CITY OF ALBUQUERQUE

Re: Blue Sky @ 12th Street
311-319 12th Street
Traffic Circulation Layout
Architect's Stamp 02-20-20 (K13-D077)

Based upon the information provided in your submittal received 02-20-20, the above referenced plan cannot be approved for Building Permit until the following comments are addressed:

PROJECT #	1906
DATE	02.20.20
SHEET #	TCL-1

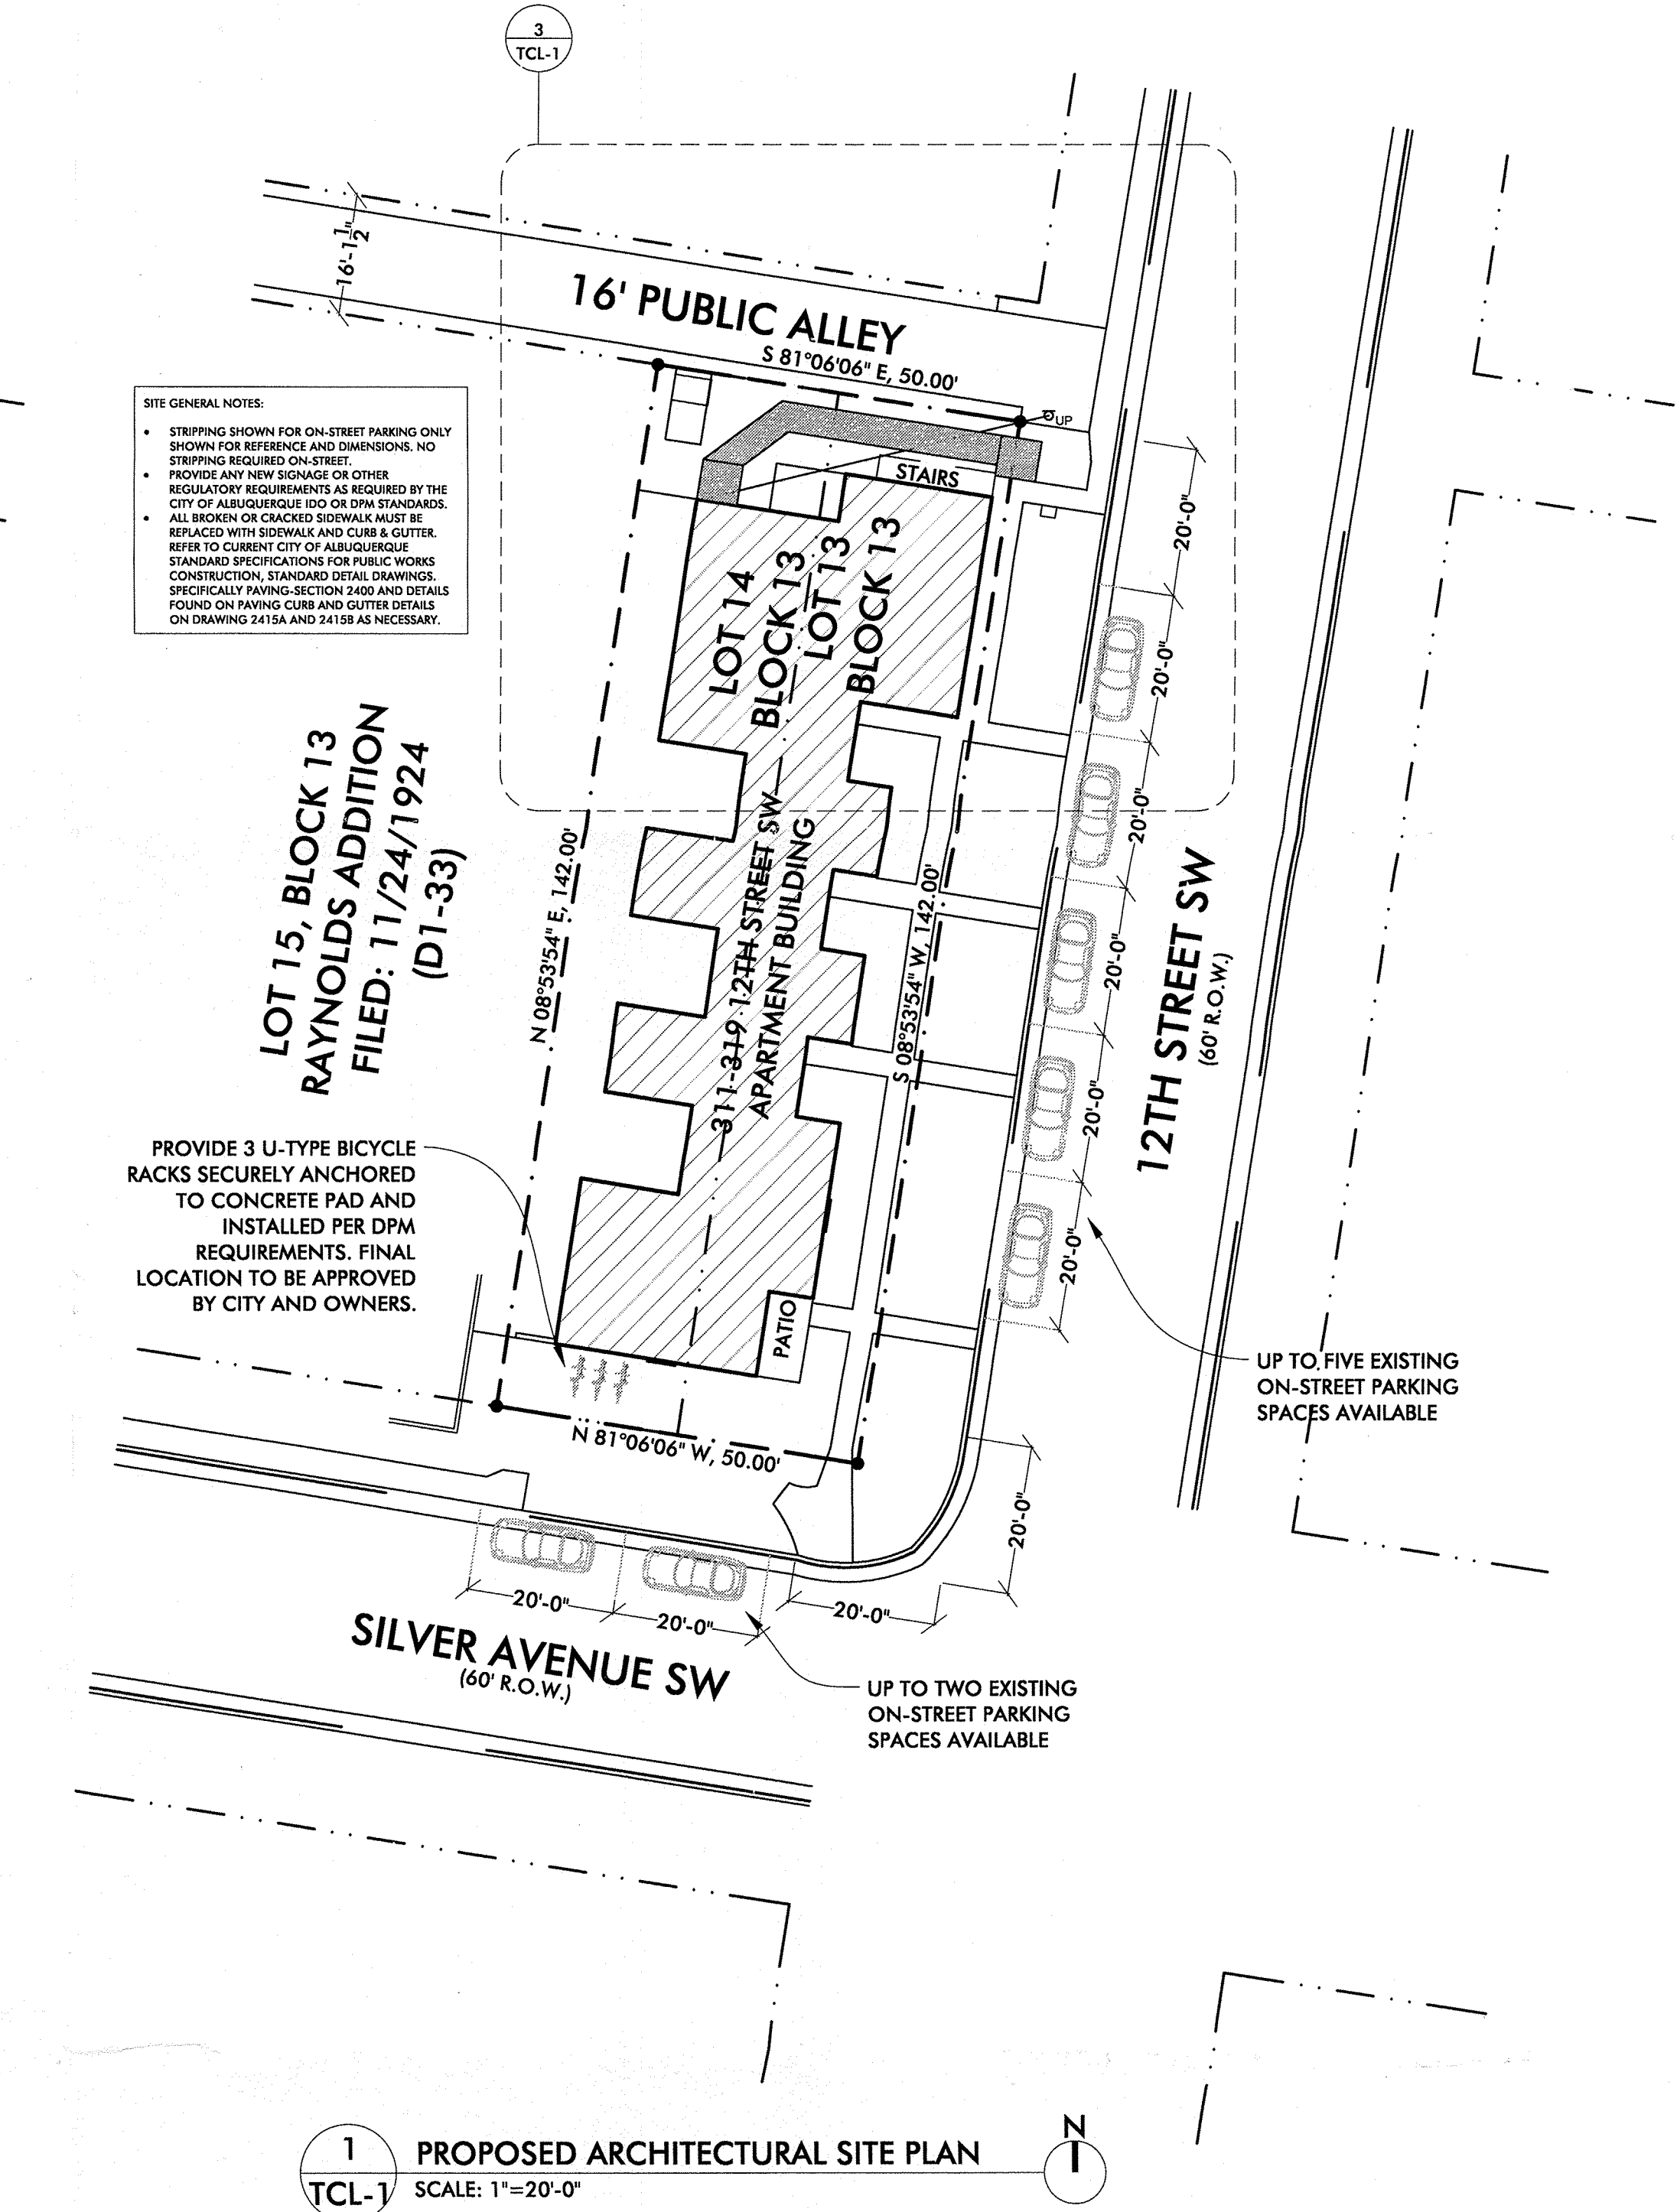
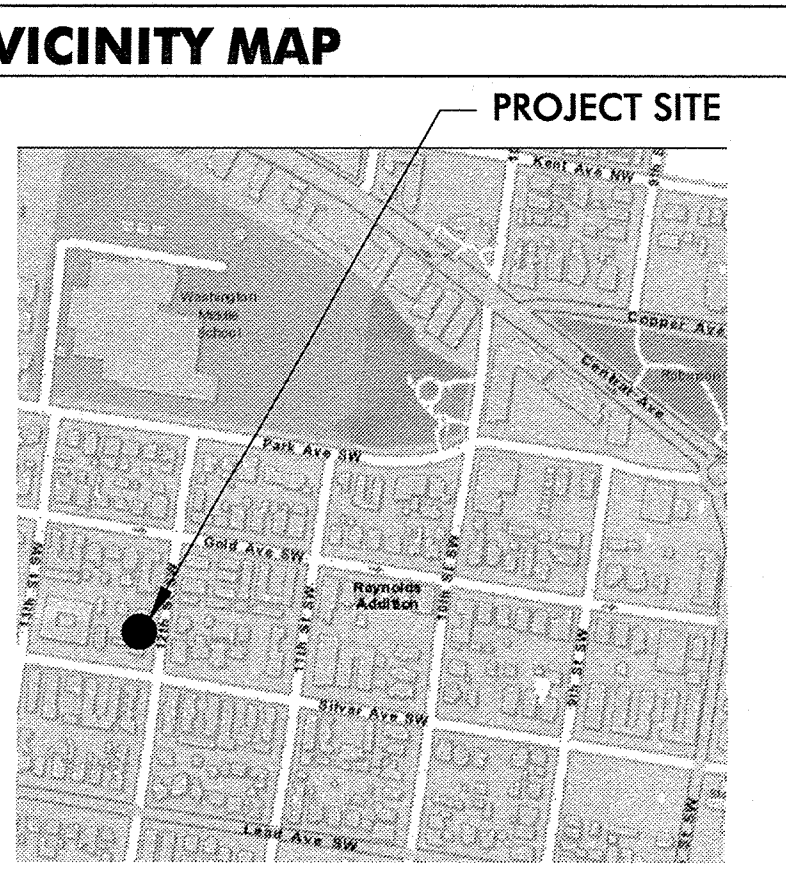
1. Please review and revise plan to provide all information listed on the attached Traffic Circulation Layout checklist.

→ PLANS (WORDING)

→ EXISTING

→ SHOWN ON-STREET SPACES AVAILABLE
ARE YOU REQUESTING A VARIANCE?
FOR THESE SPACES TO BE COUNTED AS

INCLUDED AS
YOUR REQUIRED
CALCULATION
↓ PARKING
SPACES

sidewalk and Standard C & G are shown but not labeled whether they are proposed or existing

what is the status of ADA wheel ramp at the corner of Silver Ave & 12th St.?
